# SPRINGDALE Utah

**To:** Planning Commission  
**From:** Niall Connolly, Director of Community Development  
**Date:** June 26th, 2026  
**Re:** Grading Permit at 2501 Anasazi Way

GRADING PLAN  
 FOR  
 LOT #10 ANASAZI PLATEAU PH 1  
 ADAM HYATT  
 TOWN OF SPRINGDALE, WASHINGTON COUNTY, UTAH  
 LOCATED IN SECTION 6, T42, R 10 W, S18 BM

Figure 4. Proposed grading plan

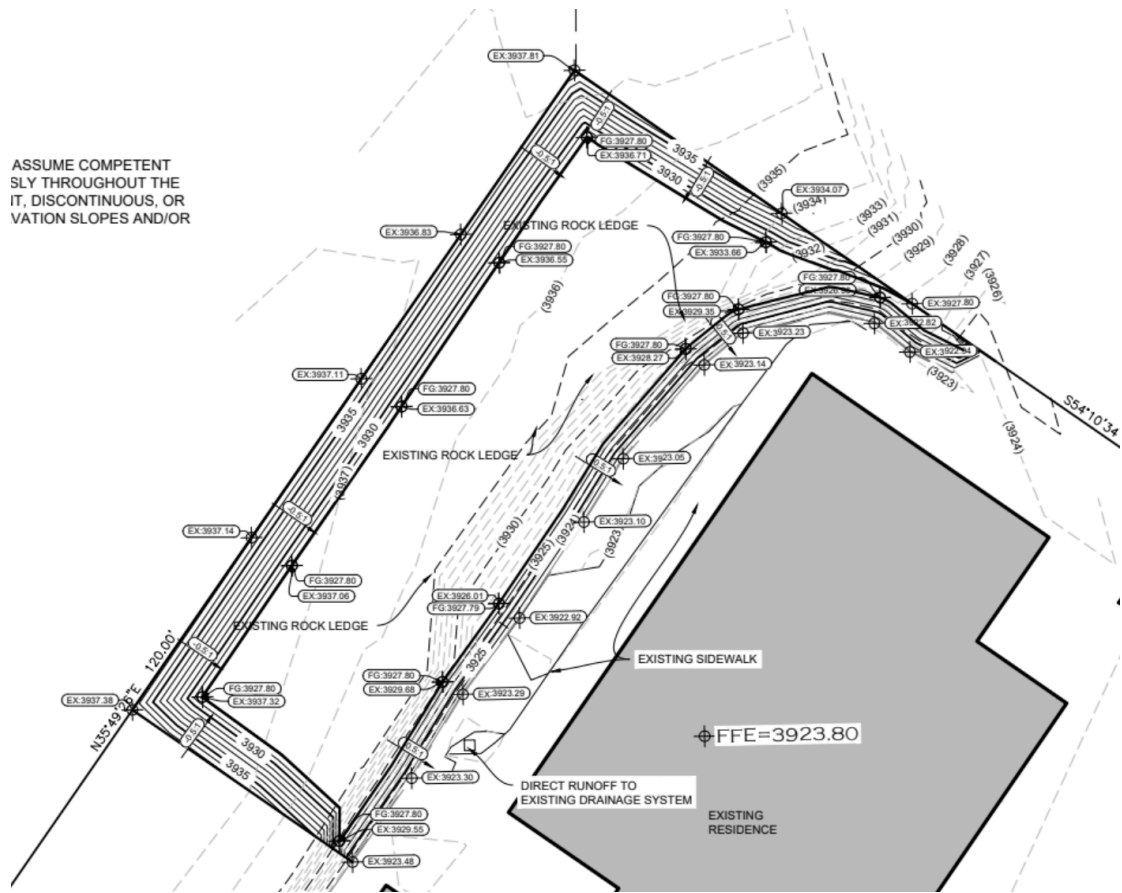
The proposed excavation will extend close to the property line, as shown in the proposed grading plan (see figure 4 below). The proposed cut slopes do not exceed 10 ft in height. Because bedrock is present, the engineers who prepared the plan do not anticipate a retaining wall will be necessary. However, the

plans note that if bedrock is found to be absent in some locations, some sections of retaining may be necessary.

Section 10-15F-5C(9) of the Code states that where an excavation is closer to the property line than twice the depth of the excavation, an assessment of the stability of the slope must be provided. This is in order to ensure the protection of sensitive features from slope failure or collapse, either during or post construction. Usually this would be provided as part of a geotechnical report. In this instance, due to the otherwise limited scope of this proposal, no geotechnical report has been needed. Instead, the applicant has provided engineered drawings of the proposed slope, as well as stamped letter from the engineer certifying the design of the cut slope and confirming that the excavation will be monitored during construction. The letter states that the excavation will be monitored, and proposes mitigation in the event that any unexpected slope stability issues arise.

1. The applicant must follow the Engineer's recommendations during construction. If loose rocks, soils or inconsistencies in the bedrock emerge during construction, the slope must be stabilized in accordance with the Engineer's recommendations.
2. In the event that a retaining wall, or sections of retaining walls are found to be necessary during construction, the applicant must submit details of the retaining wall material to the Town for approval. The material used for the retaining wall must comply with the Town's architectural standards in Section 10-16 of the Town Code.

GRADING PLAN

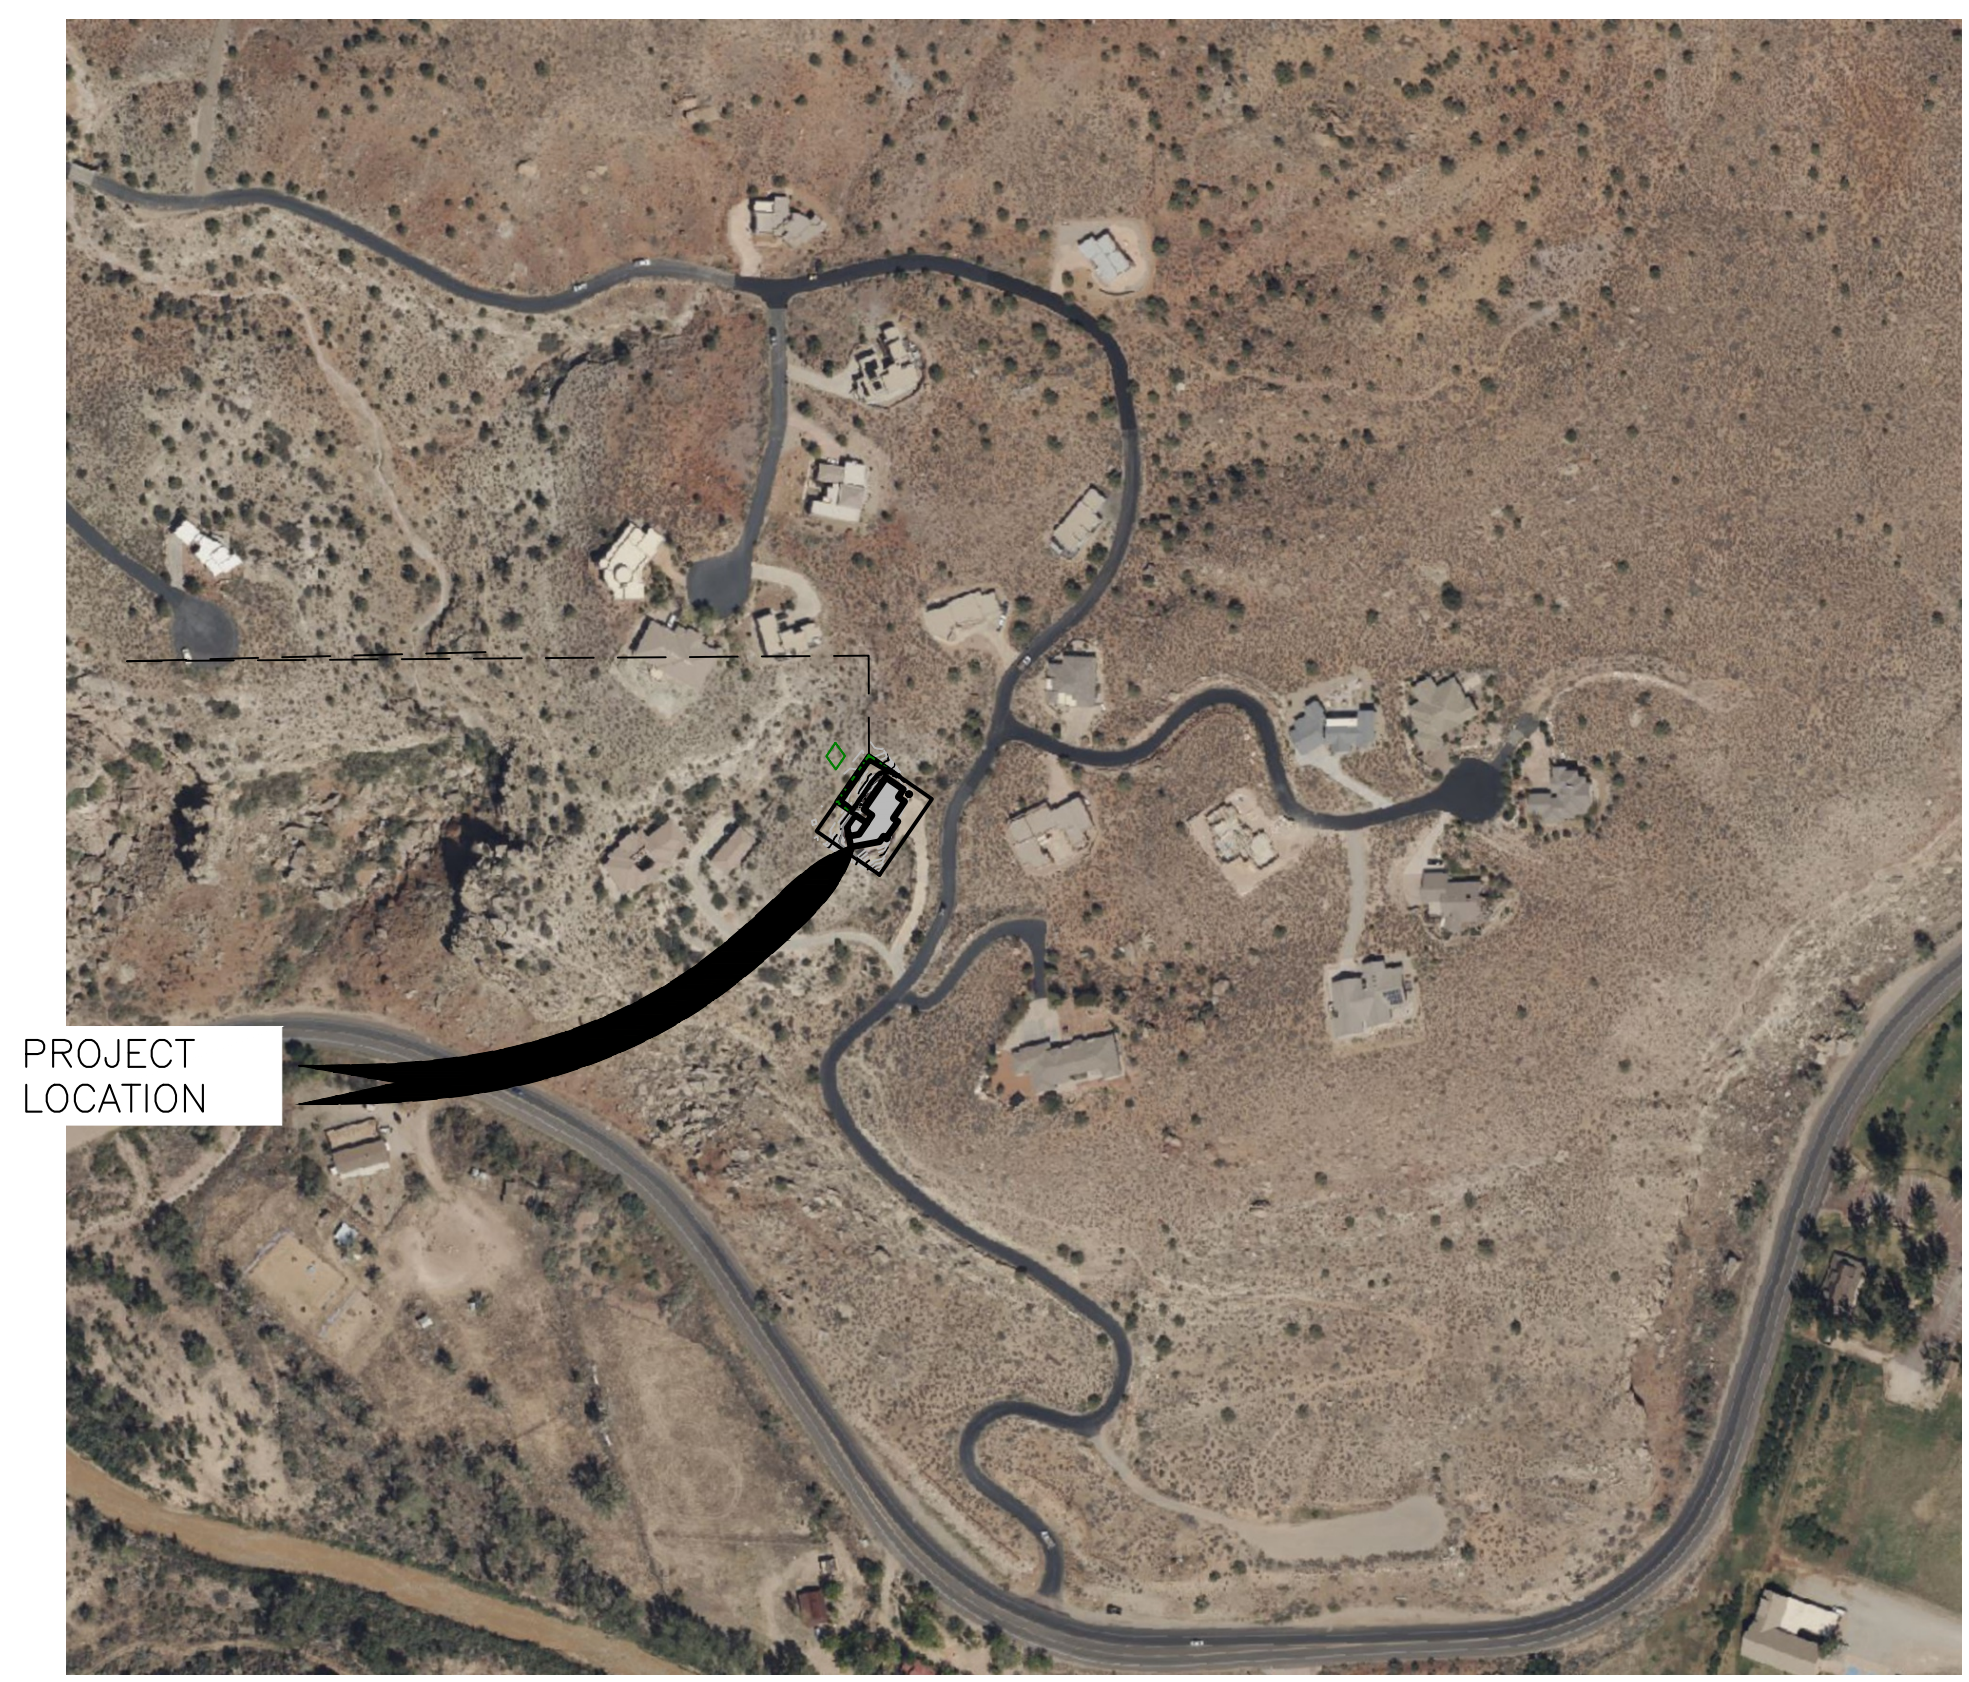
NOTE:  
 PROPOSED GRADING SLOPES OF 0.5H:1V ASSUME COMPETENT BEDROCK IS ENCOUNTERED CONTINUOUSLY THROUGHOUT THE EXCAVATION. WHERE BEDROCK IS ABSENT, DISCONTINUOUS, OR OTHERWISE UNSUITABLE, FLATTER EXCAVATION SLOPES AND/OR RETAINING WALLS WILL BE NECESSARY.

We expect substantial sandstone rock at the excavation site. We will monitor the excavation operation and if loose soils or soils other than rock are exposed, we will flatten the slope to a safe slope (1-1/2:1 or flatter) or provide a retaining wall to stabilize the slope. A retaining wall could be reinforced concrete or masonry, or a rock gravity wall could be considered.
